Universal Robotics Preliminary SP Application

SP # 2009 SP-013-001

MEMO

RE: 2009SP-013-001 – 2518 Smith Springs Road; Map 135/Parcel 334 – Response to Metro Comments

Universal Robotics Preliminary SP Site Plan

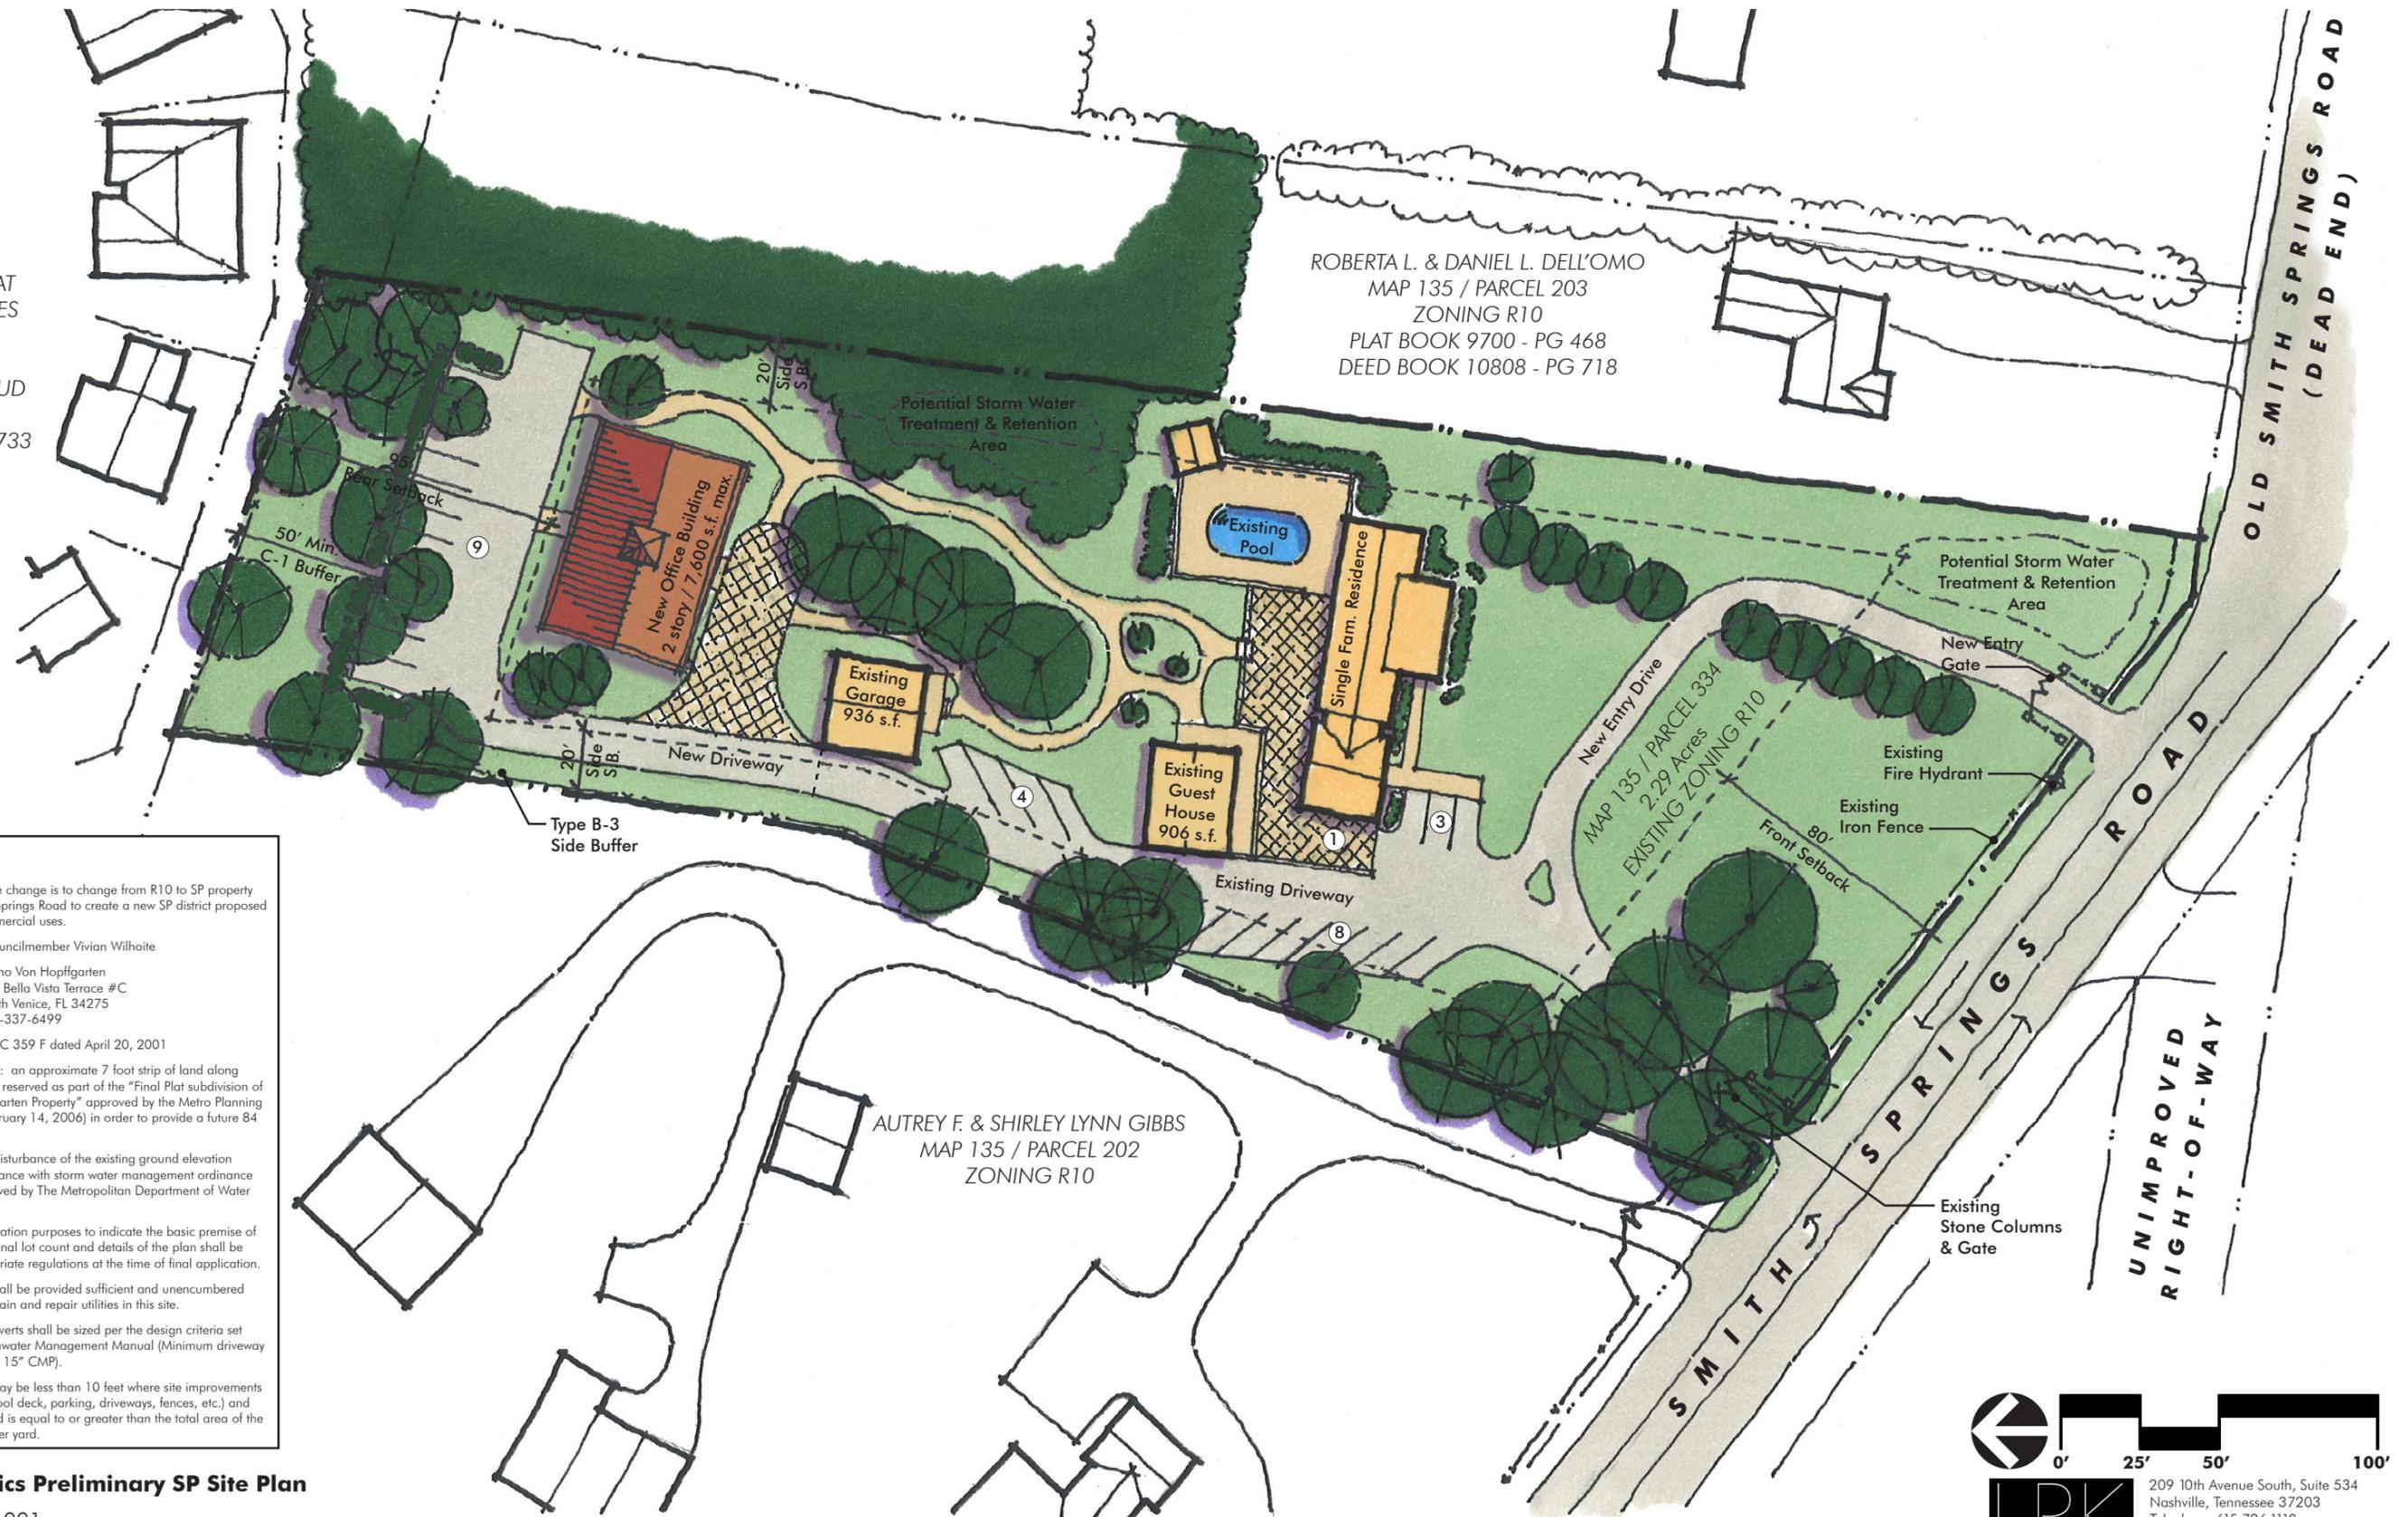
11. If the max size of a detached garage on the site can be expanded by 50% then the existing floor area should be stated on the plan (Section 5 SP Development Standards). **Response: existing floor area has been added. See Site Plan and Section 5 Development Standards.**

1. Proposed Site Layout (Scale no less than 1" = 100', Contours no greater than 5'). Add scale to plans. **Response: Site Plan is at 1" = 50'. See scale on site plan drawing.**

2. Add 78-840 Note to plans:(Any excavation, fill, or disturbance of the existing ground elevation must be done in accordance with storm water management ordinance No. 78/840 and approved by The Metropolitan Department of Water Services.) **Response: Note added. See site plan drawing.**

3. Add Preliminary Note to plans:(This drawing is for illustration purposes to indicate the basic premise of the development. The final lot count and details of the plan shall be governed by the appropriate regulations at the time of final application.) **Response: Note added. See site plan drawing.**

4. Add Access Note to plans: (Metro Water Services shall be provided sufficient and unencumbered access in order to maintain and repair utilities in this site.) **Response: Note added. See site plan drawing.**

5. Add C/D Note to plans: (Size driveway culverts per the design criteria set forth by the Metro Stormwater Management Manual (Minimum driveway culvert in Metro ROW is 15" CMP).) **Response: Note added. See site plan drawing. Stormwater department has recognized that a driveway culvert may not be required and this will be determined upon preparing Final SP application. (See e-mail from Steve Mishu dated July 17, 2009).**
6. Show Existing Topo on plans. **Response: No topographic survey is available at this time. Metro Map provided with revised application. Stormwater department has indicated that for Preliminary, a Metro Map is adequate. (See e-mail from Steve Mishu dated July 17, 2009).**
7. Affix Engineer / Architect stamp on plans. **Response: Architect's seal has been provided. See revised Site Plan.**
